**4294A-02A-S**

# **S E R V I C E N O T E**

## **Agilent 4294A Precision Impedance Analyzer**

### **POSSIBLE ELECTRIC SHOCK HAZARD**

**Figure 1. AC Inlet Connector**

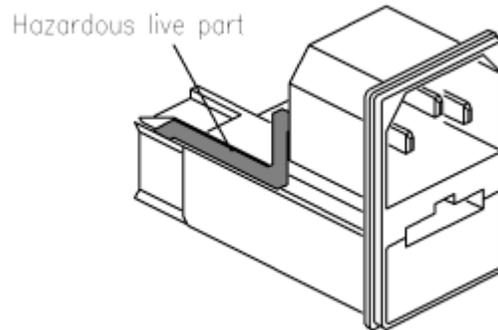
The AC inlet (P/N 1252-6951) has the potential to slip out of the instrument's rear panel slot if the AC power cord is forcefully pulled in a diagonal direction. When this happens, an exposed connection on the AC inlet module may touch the rear panel of the instrument and cause an electrical short if the AC power cord is still connected to the AC power outlet. See Figure 1.

- Remove the AC power cable from the AC power outlet and the product.
- Remove the top, bottom, and side covers.
- Replace the rear panel assembly with P/N 04294-00213.
- Install the new fuse P/N 2110-1303.
- Perform Self Test to verify instrument operation.
